ADDENDUM TO REPORT FOR ITEM LPP05 DATED 1 JUNE 2021

SUBJECT: 15 WAIWERA STREET, LAVENDER BAY

APPLICATION NO. DA 20/21

AUTHOR: HUGH SHOULDICE, ASSESSMENT OFFICER

DRAWING TITLE
Planting Plan - Trees

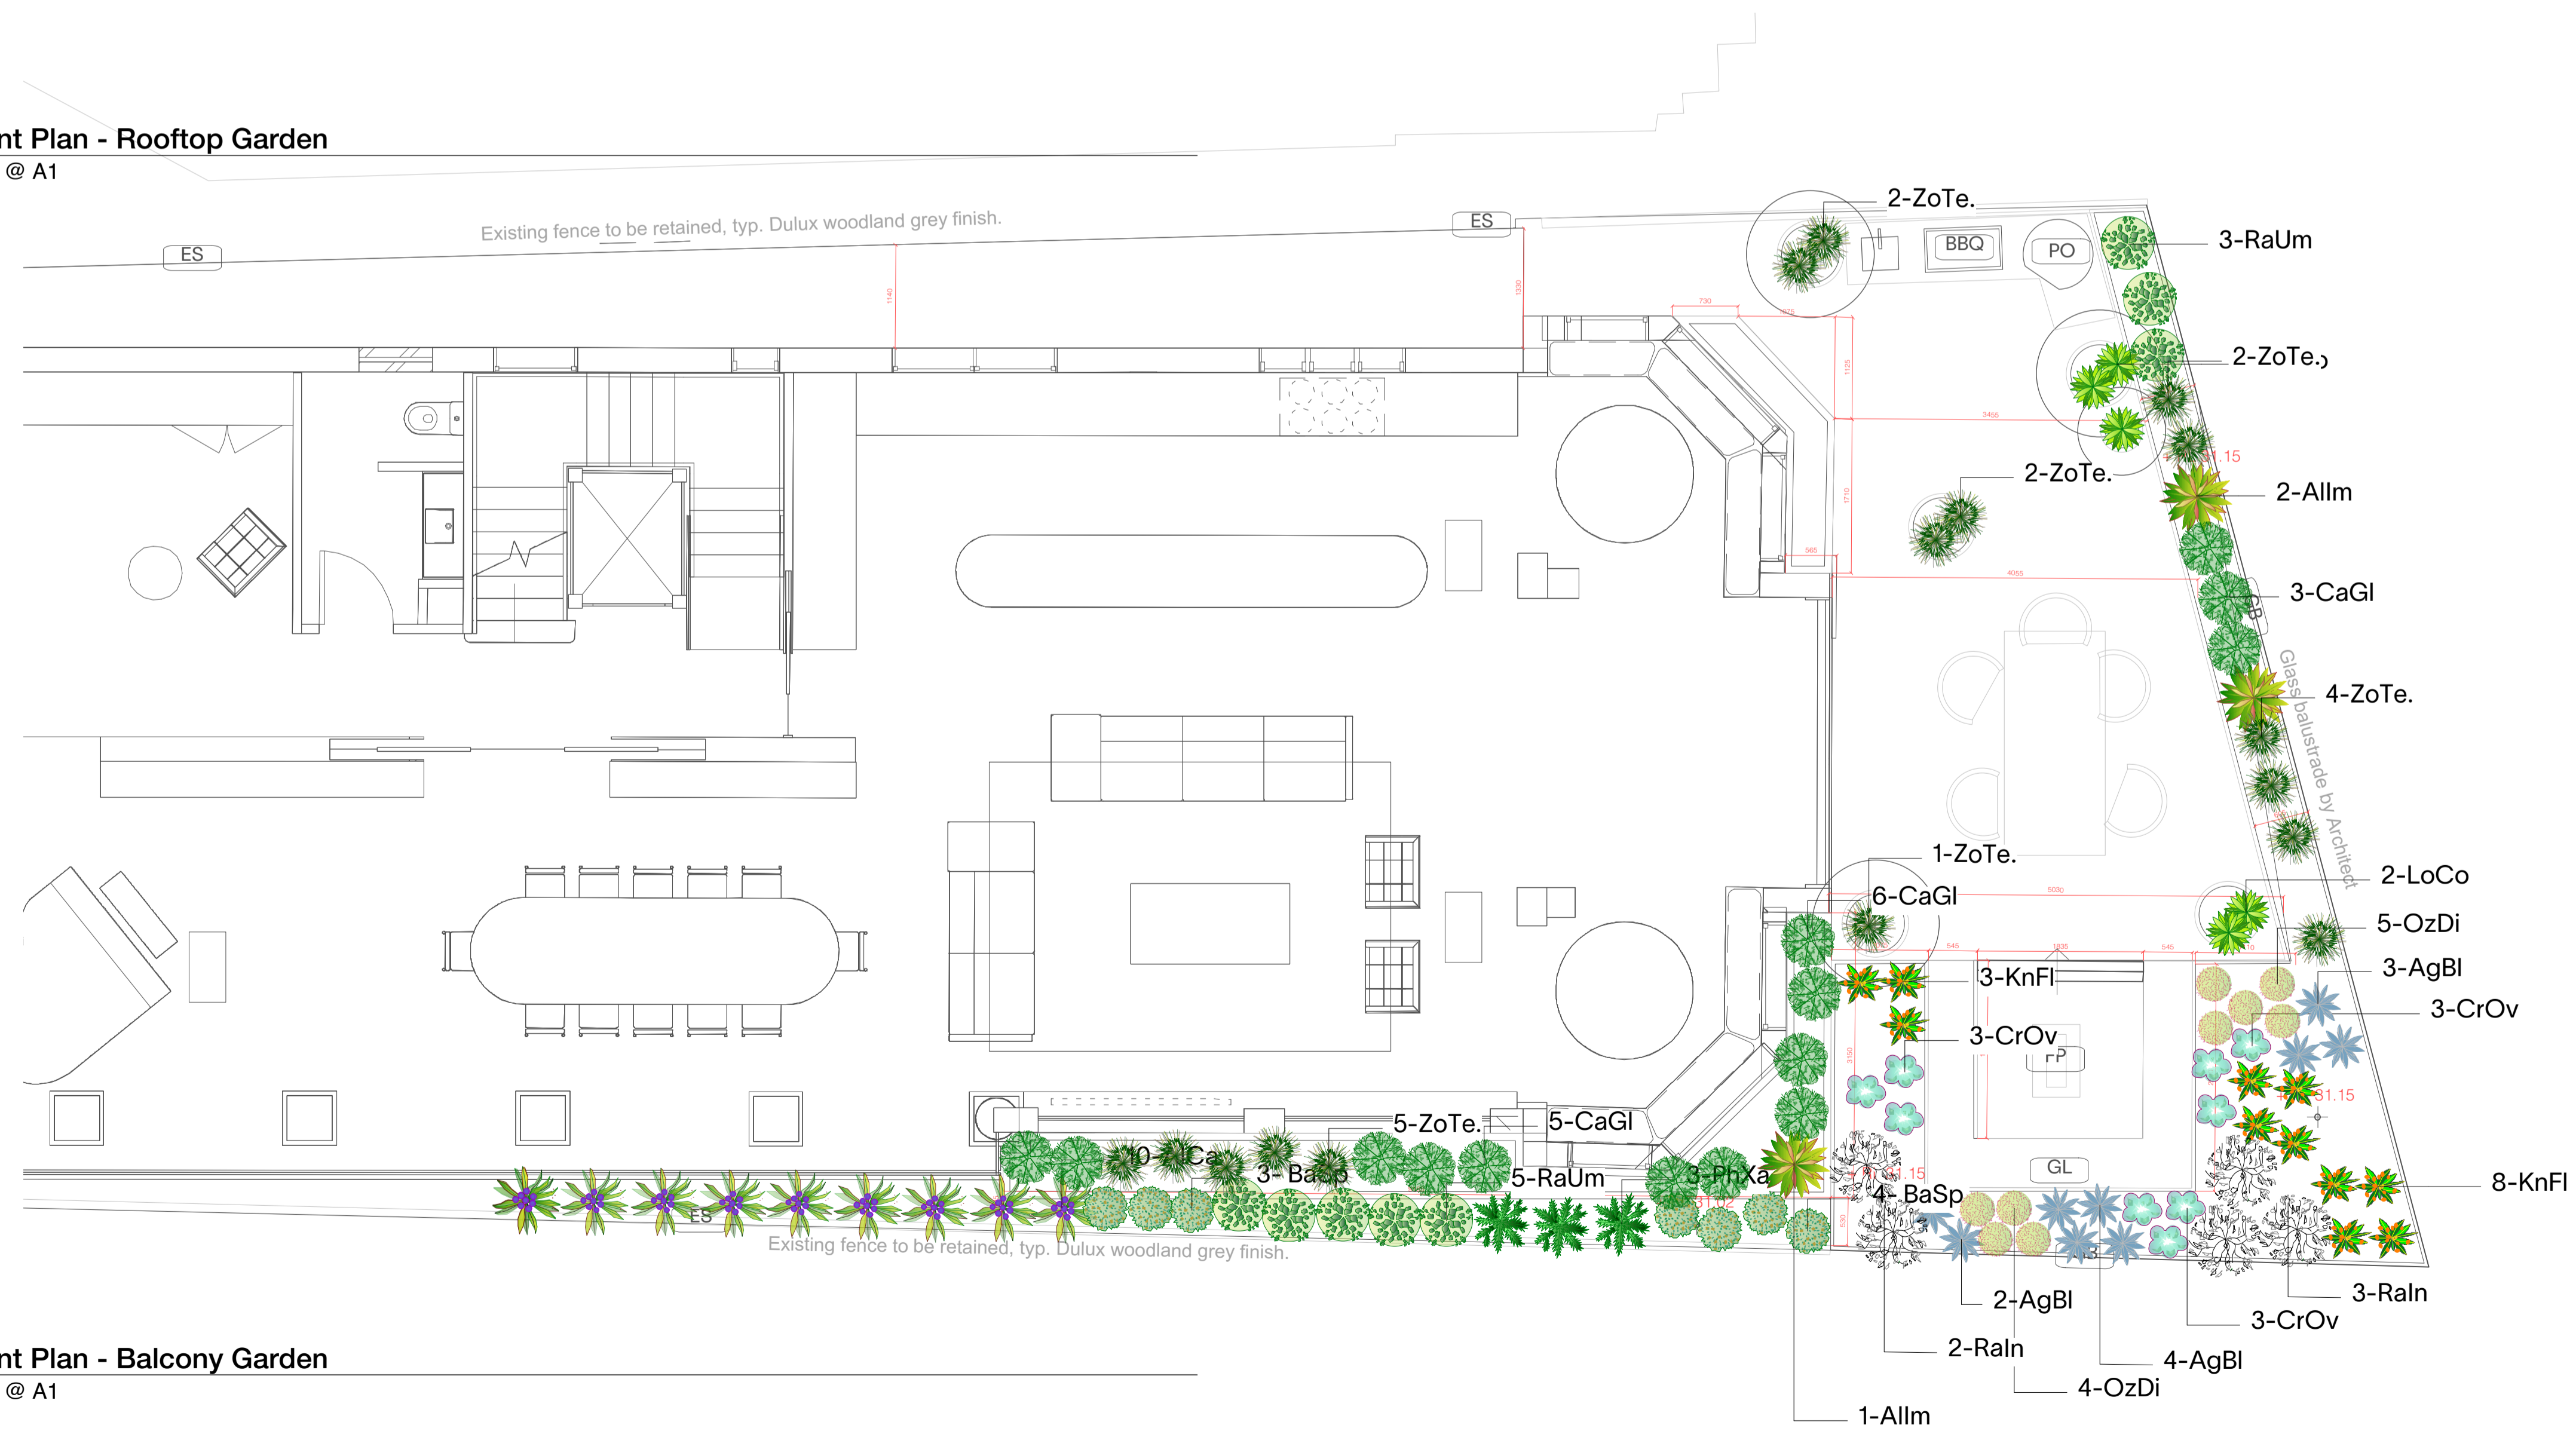
- *The Landscape Plan prepared by Philip Withers dated 18/11/20 is considered to be inaccurate –claiming that a total of 19 new trees are to be planted. The majority of these are claimed to be “trees”. However, they are considered to be small shrubs, palms, ferns or perennials, with only 2 actual canopy trees included in the claimed total of 19 trees (2 x Banksia serrata).*

- *An amended proposal ... that allows for the retention of T2 and T4, includes an amended arborist report with a detailed Tree Protection and Management Plan for same, and an amended Landscape Plan that accurately includes details of all plants is required. It should also ensure that plants chosen are characteristic of heritage plantings, and are not simply chosen due to their status as native plants (NSC while applauding the use of native plants, does not require their use per se, but prefers a planting palette in keeping with all site, locality, and heritage considerations).*

- The existing *Phoenix canariensis* (T4) is shown to be relocated within the subject site.
- A replacement mature *Magnolia grandiflora* (T2) is to be shown planted within the subject site.
- A tree planting schedule is to be provided on each sheet of the landscape plans.
- A heritage consultant with expertise in the landscaped design is to provide written certification that the revised design is consistent with the approved built form and heritage significance of the subject site.

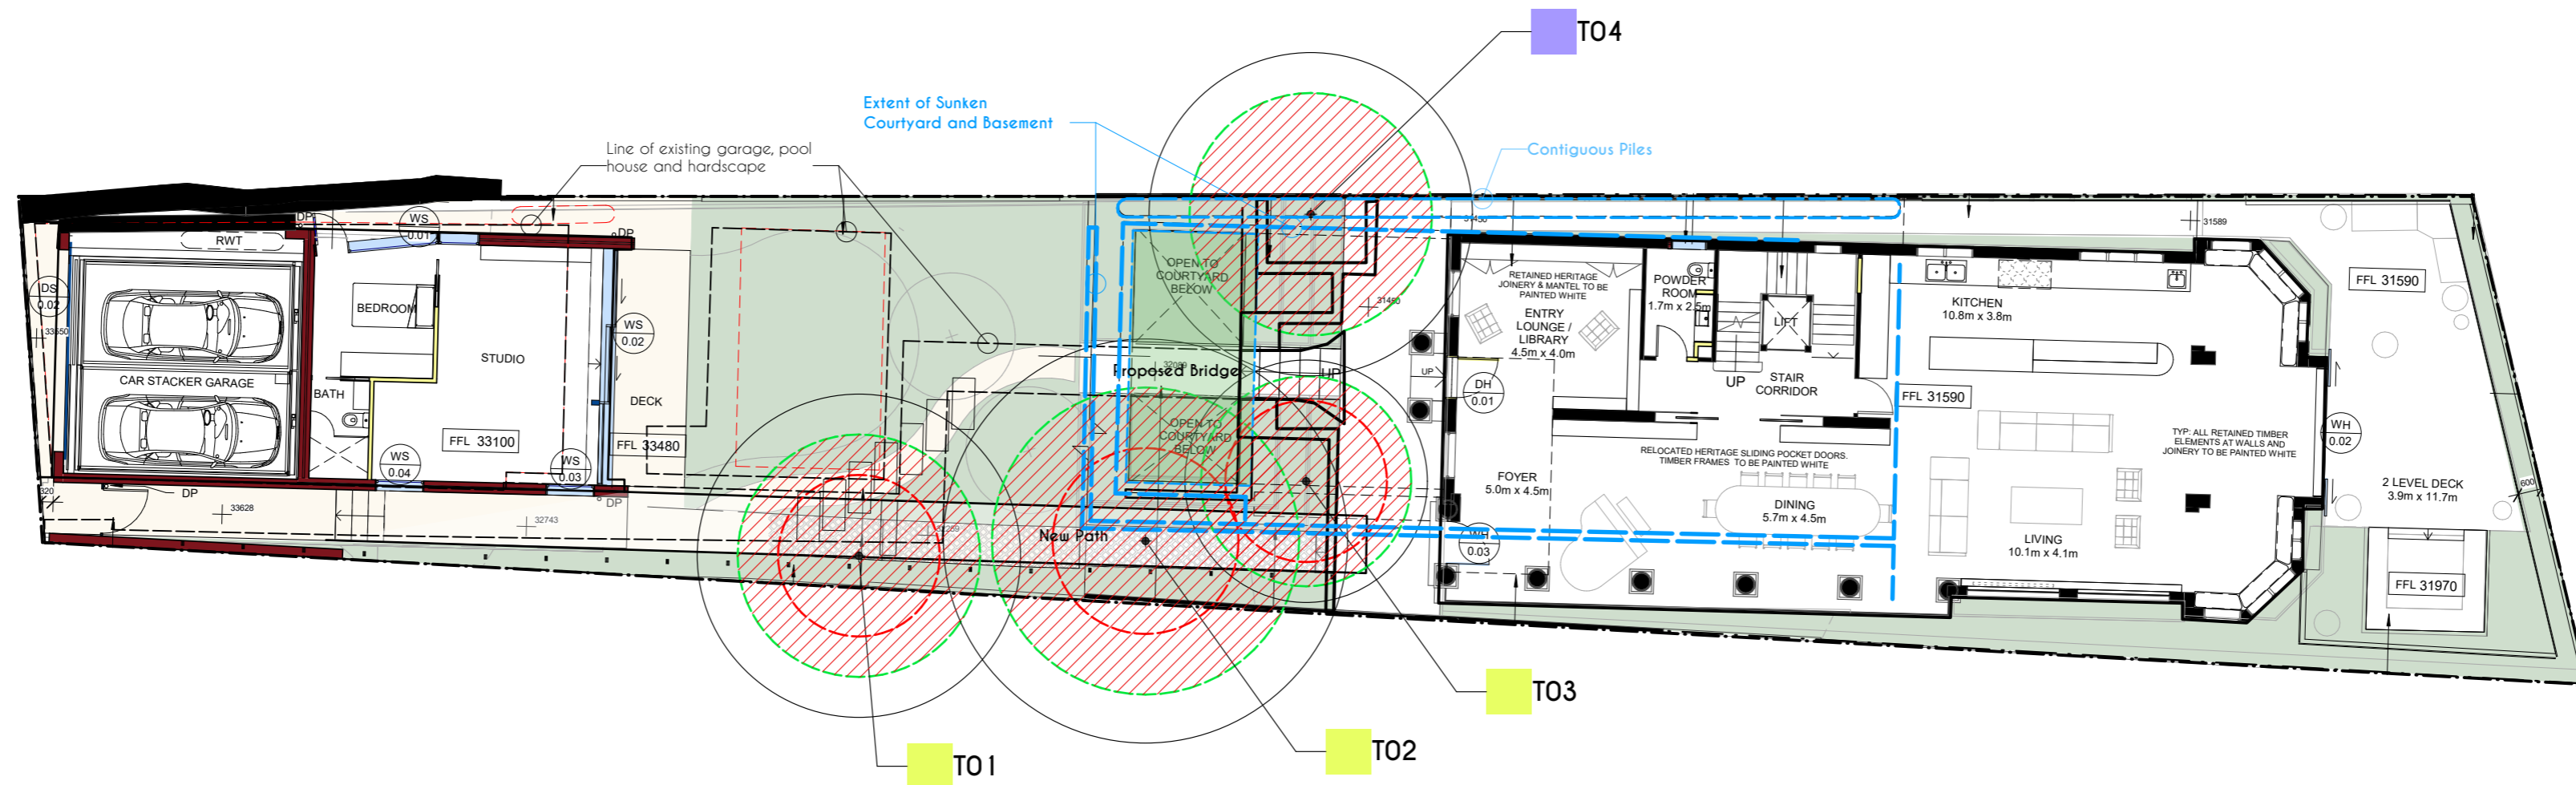
- *The removal of all site trees, and lack of adequate replacement trees is considered unacceptable.*
- *No objection is raised to the removal of T1 *Murraya paniculata* (6x8m) and T3 *Murraya paniculata* (6x6m) subject to suitable replacement planting.*
- *The removal of T2 *Magnolia grandiflora* (12x10) and T4 *Phoenix canariensis* (14m) cannot be supported. Both these mature trees are in good health and are characteristic of heritage planting within the LGA.*
- *The assertion contained within the Arborist Report prepared by Tree Management Strategies dated 1/12/20 that "The Landscape Plan prepared by Phillip Withers proposes the planting of 2 x *Banksia serrata*, 1 x *Acer seiryu*, 1 x *Laegerstromia* (sic) *comanche*, 3 x *Cyathea cooperi* and 1 x *Howea forsteriana* to adequately compensate for the removal of Tree 4" is not supported.*

The comments provided by Council’s Landscaping Officer identify that the removal of *Magnolia grandiflora* (T2) and *Phoenix canariensis* (T4) should not be supported on heritage significance grounds. However, the removal of the *Magnolia* T2 can reasonably be supported on the basis that a suitably mature replacement tree could achieve an appropriate landscape response for the site, whilst enabling the proposed works to proceed.

The proposed removal of the Phoenix Palm (T4) however, should not be supported in full, for the reasons expressed above. Based on the comments above, it is recommended that *Phoenix canariensis* (T4) be considered for transplantation elsewhere within the site, subject to appropriate conditions to accommodate the tree in a suitable location, and subject to a review from an expert in heritage landscape design. Amended conditions are outlined below which provide for this change.

C26. Tree 4 Phoenix Canariensis is to be transplanted within the subject site, to a suitable location between the dwelling and the approved garage. A written methodology is to be prepared by a consulting arborist with a qualification AQF Level 5 detailing the required methodology for the safe and effective transplantation of Tree 4.
